SERVICE BULLETIN

Service Bulletin No.: DAC1-33-01 Rev.1

Title: Recognition Lights

Figure 1

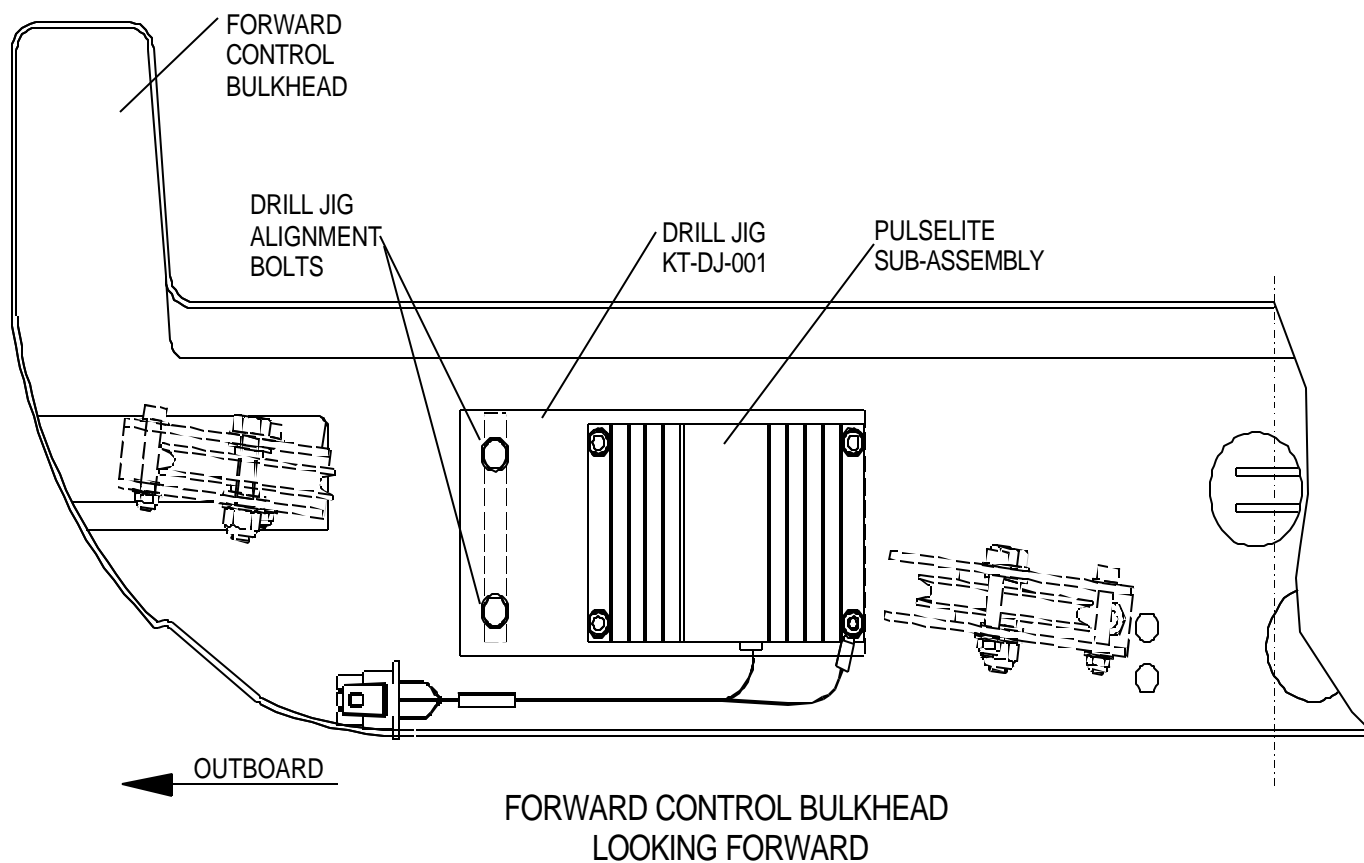
- 10.11 Install the nutplates (P/N MS21047-08) with rivets (P/N CCR244SS-3-05).
- 10.12 Seal the edges of the cutout with resin.
- 10.13 Locate the Pulselite power supply using drill jig (P/N KT-DJ-001). Refer to Figure 1.

- 10.14 Install the pulselite power supply as shown in Figure 1.

Figure 3

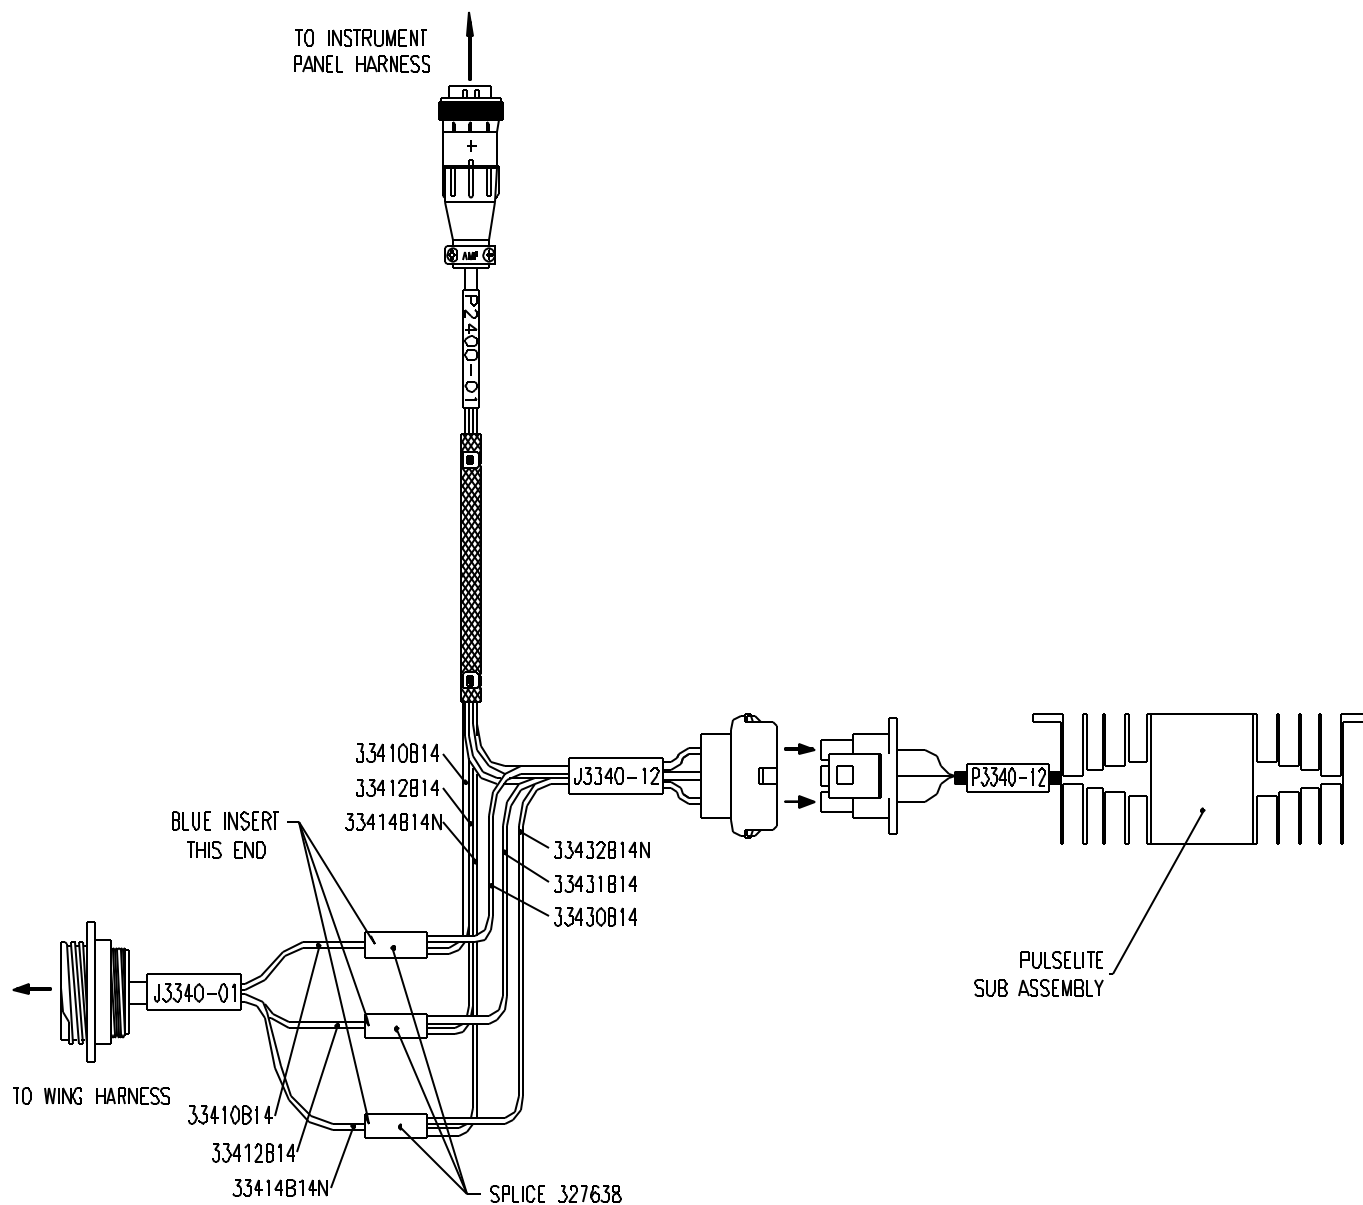
- 10.36 Install the new switch placard and new circuit breaker placard.
- 10.37 Find the existing taxi and landing light wire #334410B14 and wire #33414B14N, near the Pulselite power supply where the fuselage harness routes through to the wing route. See figure 3.

- 10.38 Cut wire #33410B14 and splice exactly as shown in Figure 3.
- 10.39 Cut wire #33412B14 and splice exactly as shown in Figure 3.
- 10.40 Cut wire #33414B14N and splice exactly as shown in Figure 3.

Figure 4

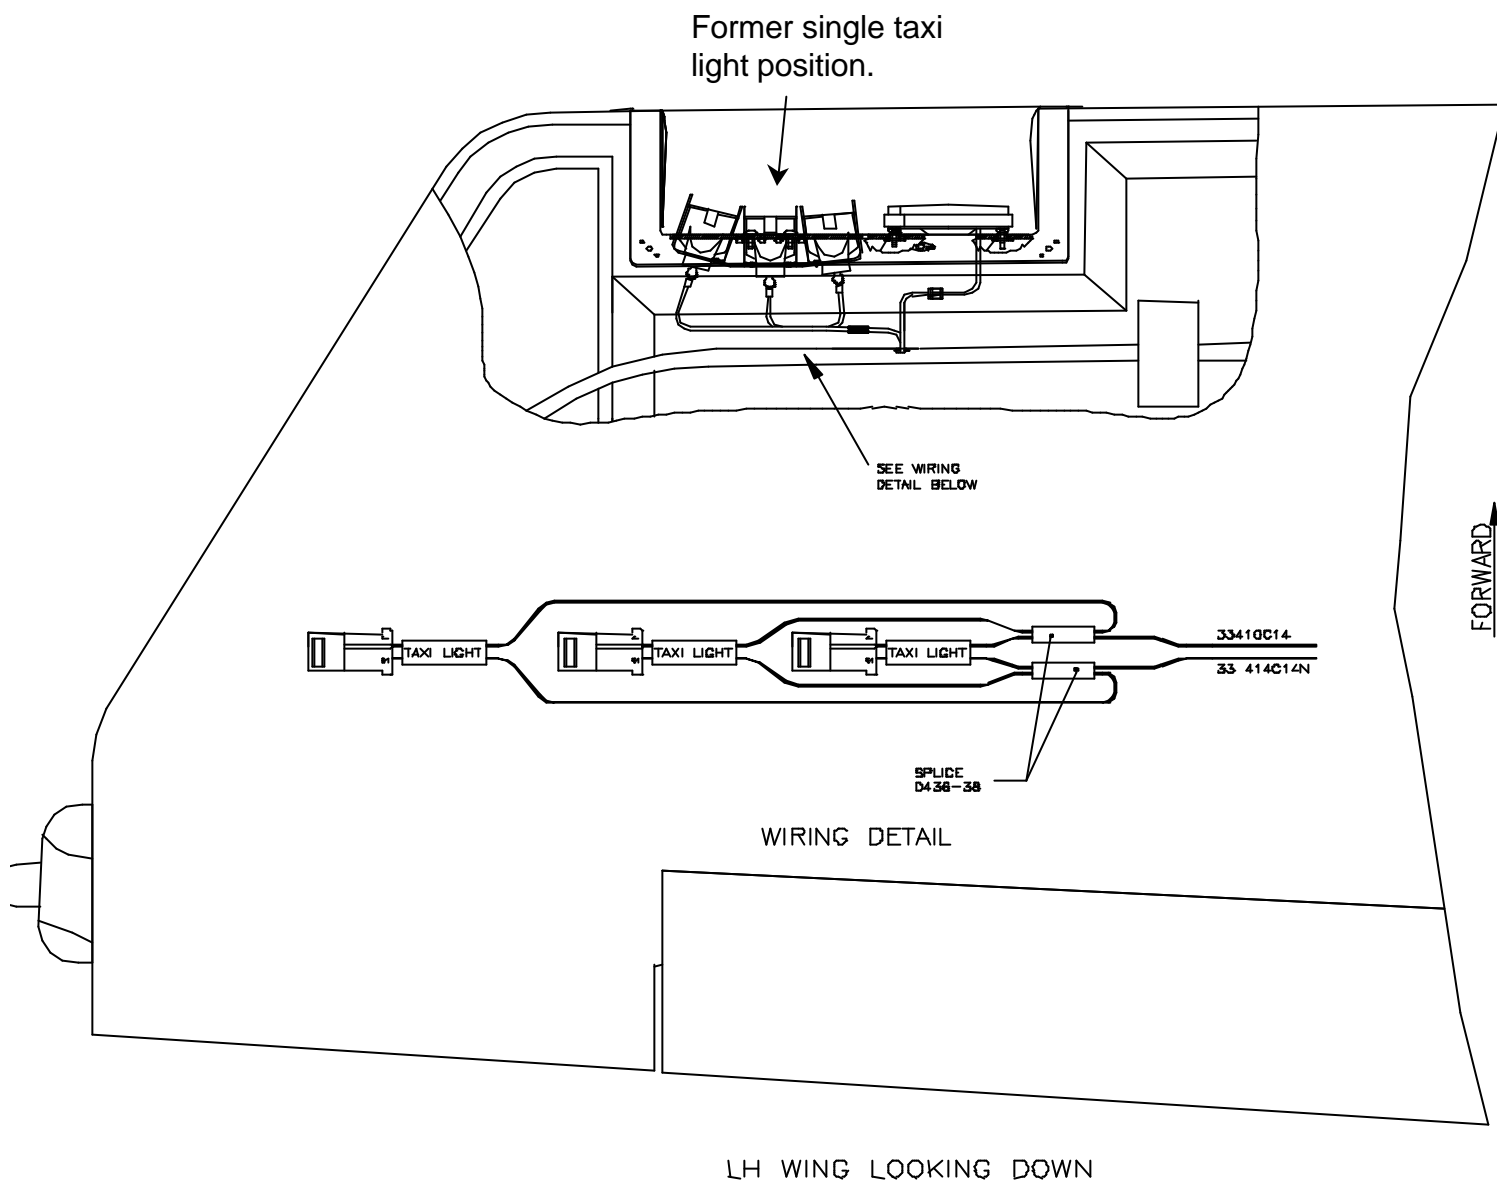
- 10.41 Connect the Pulselite power supply to the fuselage harness.
- 10.42 Cut the connector from the taxi light wires as shown in Figure 4. Splice the lamp extension wires to the existing taxi light wiring using raychem AD-1377 tool.

Figure 5

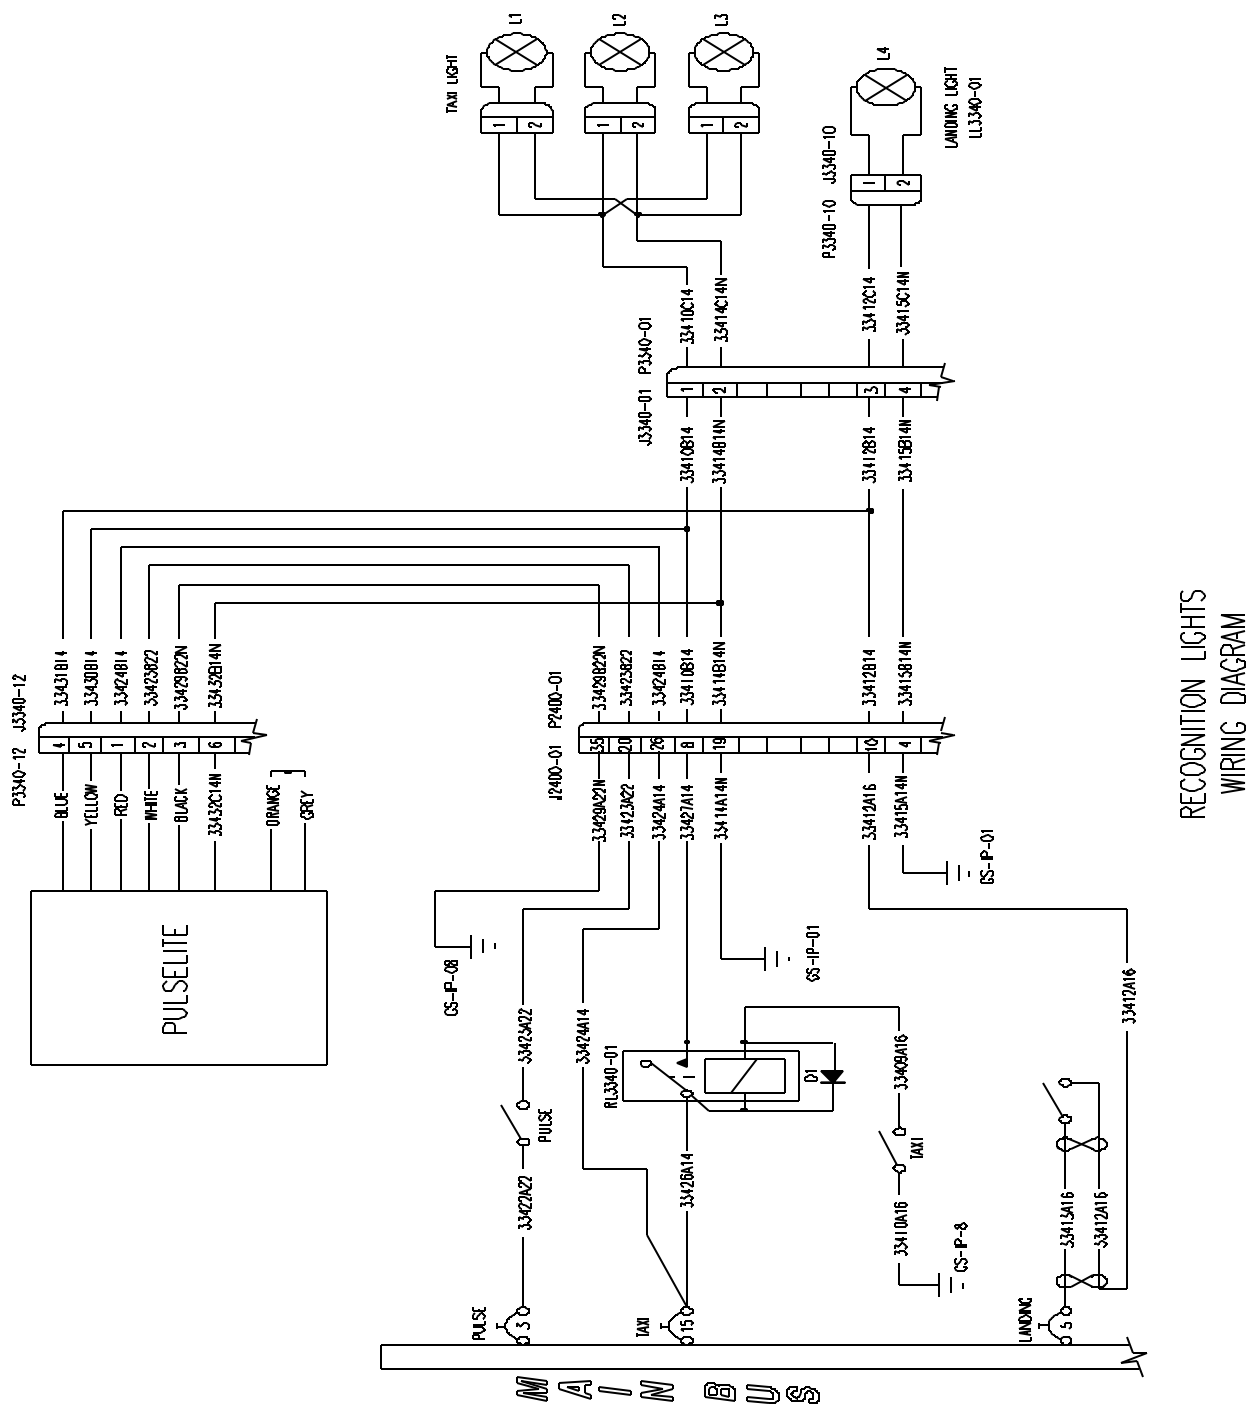
- 10.17 Refer to the wiring diagram (Figure 5). Disconnect P2400-01 from J2400-01. Release the back shell from P2400-01. Insert wire #33424B14 into position 26, insert wire # 33429B22N into position 35, insert wire #33423B22 into position 20.
